Addendum 15: United Nations Global Technical Regulation No. 15

Worldwide harmonized Light vehicles Test Procedures (WLTP)

Amendment 6 – Appendix 1

Technical report on the development of Amendment 6 to UN GTR No. 15 on the Worldwide harmonized Light vehicles Test Procedure (WLTP)

Table 1

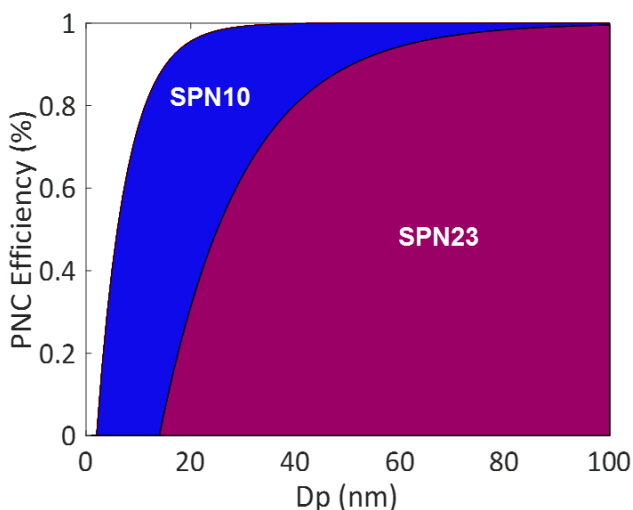
<i>Subject</i>	<i>UN GTR 15, Annex 5 – Original requirements</i>	<i>Proposed changes for SPN23</i>	<i>Proposed changes for SPN10</i>	<i>Reasoning</i>
PNC efficiency	50±12 % @ 23 nm, >90% @ 41nm	None	65±15 % @ 10 nm, >90% @ 15nm	Typical PNC-efficiency, well tested in the field.
Maximum VPR-loss requirement	@ 30nm 30% and @ 50 nm 20% higher than @ 100 nm	None	Addition @15 nm 100 % higher than at 100 nm	No additional requirement below 15 nm since generation of particles < 15 nm challenging, uncertainties high
Polydisperse validation of VPR	a polydisperse 50 nm aerosol may be used for validation	None	Removed	Uncertainties @ 15 nm or below high → test serves no purpose
VPR validation	> 99.0 % vaporization of 30 nm tetracontane particles, with an inlet concentration of ≥ 10,000 per cm ³ (Monodisperse)	None	> 99.9 % removal efficiency of tetracontane particles with count median diameter > 50 nm and mass > 1 mg/m ³ . (Polydisperse)	Secure the functioning of VPR also for PNC with 65±15 % @ 10 nm, >90% @ 15nm

Volatile Particle Remover (VPR)	All parts (of SPN-system) -- shall not react with exhaust gas components	-- VPR may be catalyzed (both heated evaporation tube and catalytic stripper allowed)	- the VPR shall be catalyzed (use of catalytic stripper only)	Minimize the risk of artefacts for SPN10. Comparability of PNC10 and PNC23 and possibility of using new sampling systems with CS also for SPN23 by fitting a PNC with a

<i>Subject</i>	<i>UN GTR 15, Annex 5 – Original requirements</i>	<i>Proposed changes for SPN23</i>	<i>Proposed changes for SPN10</i>	<i>Reasoning</i>
				D50 @ 23 nm.
